**Sub.:** Proposal for Amendment in Environment Clearance – **Change in Fuel Source and Fuel Mix pertaining to Mahan Aluminium Project of Hindalco Industries Limited.**

**Ref.:** Letter No. J-11011/217/2007-IA-II (I) dated 18.03.2009 and subsequent Amendment dated 15.02.2012.

विषय: Integrated Aluminium Smelter complex along with coal based Captive Power plant at singrauli,  
MP by Hindalco industries Limited- reg.

**Monitoring implementation of Environmental Safe Guards**  
**Ministry of Environment & Forest Western Region,**  
**Regional Office Bhopal**

Photo 2 - Continuous emission monitoring system at Pot room stack

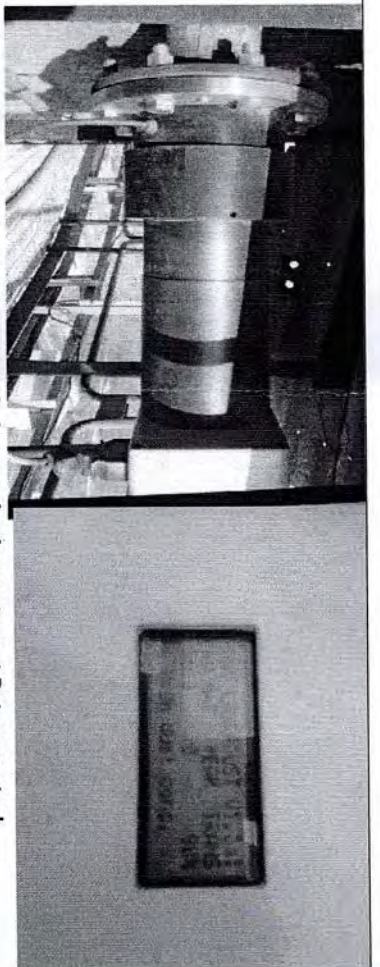
Continuous fluoride emission monitoring system shall be installed at pot room stack.

Continuous fluoride emission monitoring system has been installed at pot room stack. The photograph of continuous fluoride monitoring analyzer installed at pot room.
